Service Information: **New design and features improvement**

Corteco No **12010929B**

NEW DESIGN FEATURES IMPROVEMENT

Figure 1: old design

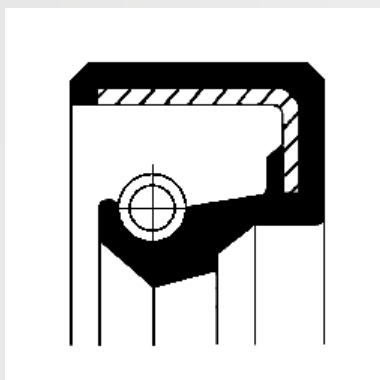
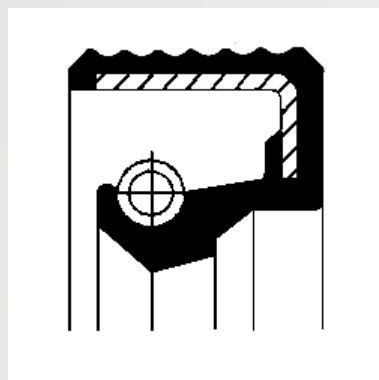
The design of the new oil seal 12010929B has changed in size and shape in order to ensure a better functionality:

- the height is now 7 mm, instead of 10 mm;
- a grooved outer diameter has replaced the old smooth version.

The new outer diameter grooved surface ensures better performance in the static sealing area.
